ADDENDUM

Project: Science Building Research Wing Expansion

Project No. 03049

Addendum: No. 1

SMMA Symmes, Maini & McKee Associates 1000 Massachusetts Avenue Cambridge, MA 02138	UNIVERSITY OF SOUTHERN MAINE PORTLAND, MAINE	DATE 04/28/04	SKE-05
		SCALE 1/8"=1'-0"	
PENTHOUSE PLAN & BASEMENT PARTIAL PLAN POWER REVISION		DR. BY CDN	CK. BY SD
		JOB NO. 03049.00

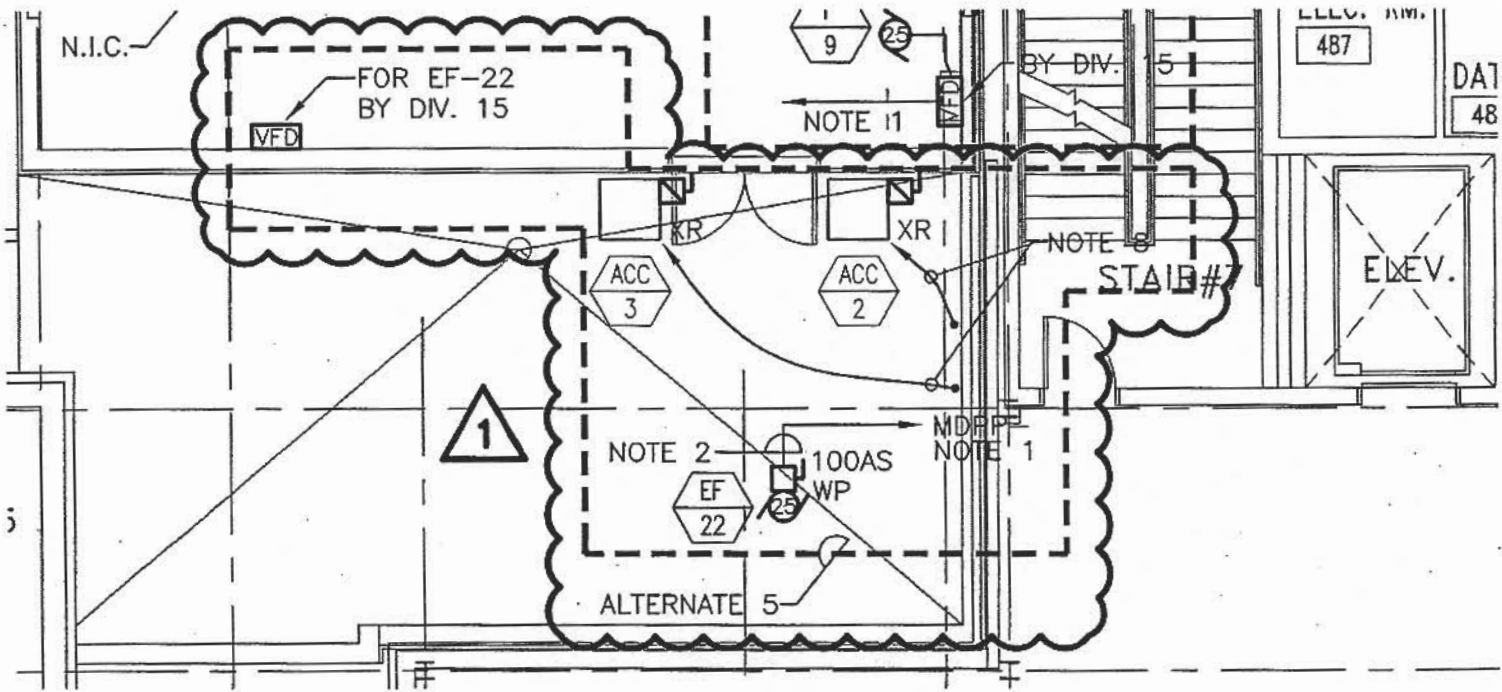
1. Make changes shown on SKE-05.

1 8. DUE TO UNITS' RELOCATION, E.C. SHALL DISCONNECT THESE UNITS, EXTEND POWER FEEDERS (PANEL "MPP") TO NEW LOCATION AND RE-CONNECT THEM BACK.

Symmes, Maini & McKee Associates 1000 Massachusetts Avenue Cambridge, MA 02138	UNIVERSITY OF SOUTHERN MAINE PORTLAND, MAINE	DATE	04/28/04	SKE-06
		SCALE	1/8"=1'-0"	
POWER ONE-LINE DIAGRAM PHASE 2 REVISION		DR. BY	CK. BY	JOB NO.
		CDN	SD	03049.00

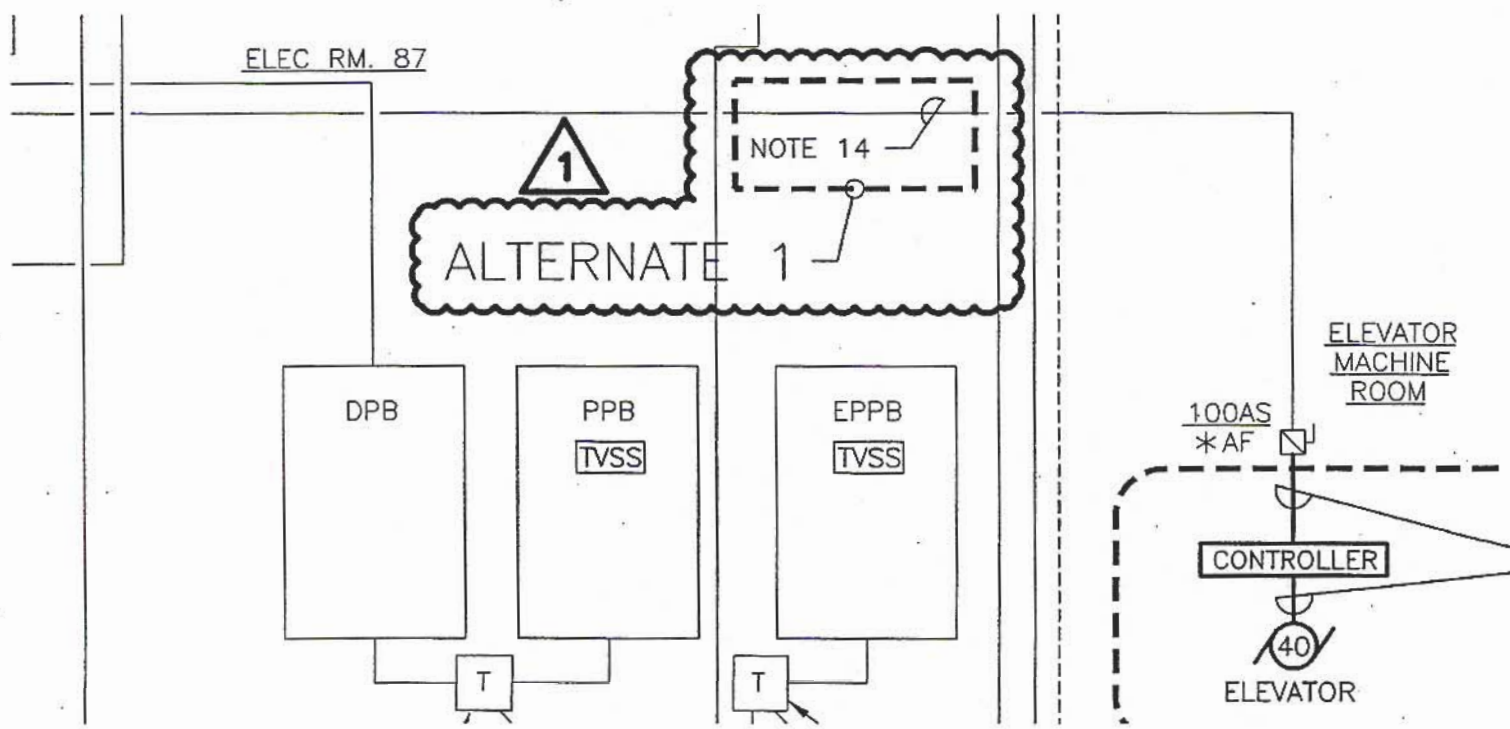
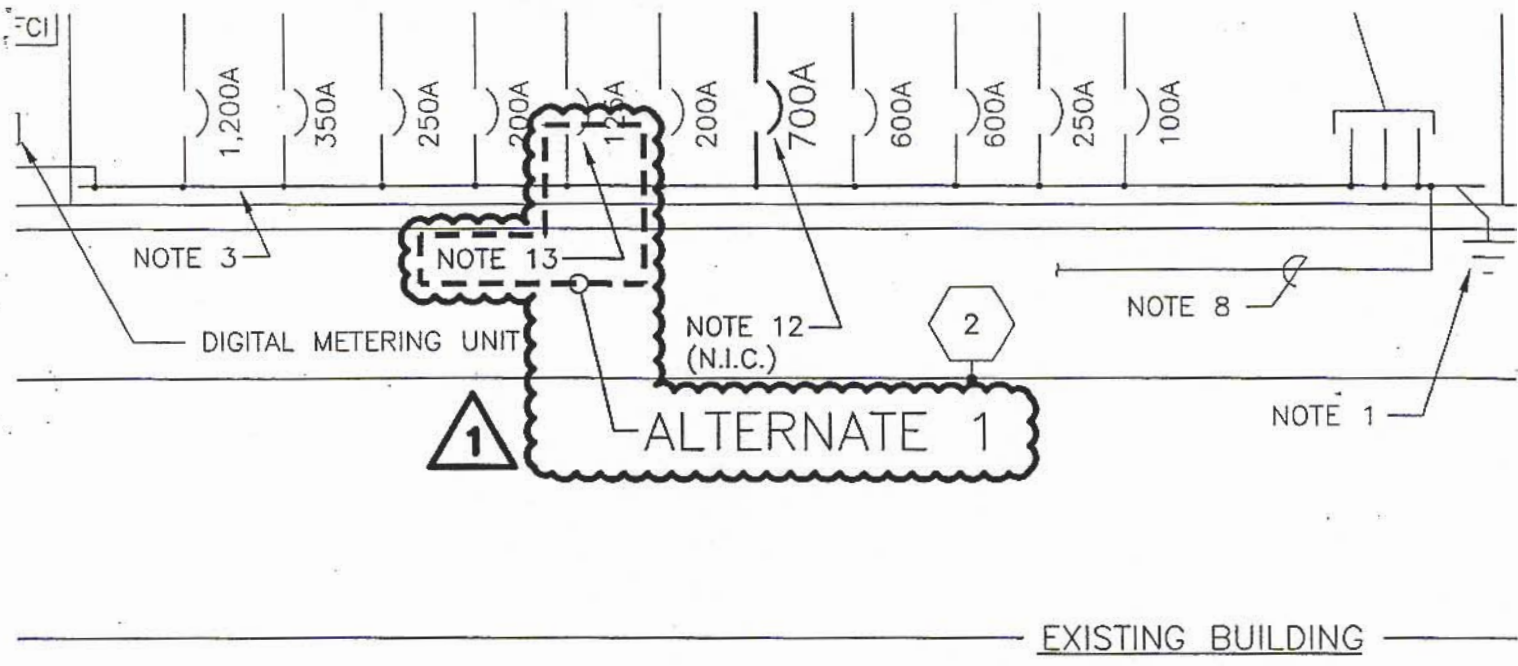
1. Make changes shown on SKE-06.

- 13. EXISTING CIRCUIT BREAKER WITH SHUNT TRIP SHALL BE FIELD-RETROFITTED WITH AUXILIARY SWITCH CONTACTS, TYPE AS REQUIRED TO SWITCH POWER TO EMERGENCY BATTERY-POWERED LOWERING UNIT.
- 14. E.C. SHALL VERIFY IF ELEVATOR WIRING FROM MAIN SWITCHBOARD HAS BEEN PULLED WITHIN SCOPE OF PREVIOUS PHASES. IF NOT, IT SHALL BE CONSIDERED IN SCOPE OF THIS PROJECT: PROVIDE 3#4 & 1#6GND. IN EXISTING 1-1/4" CONDUIT.
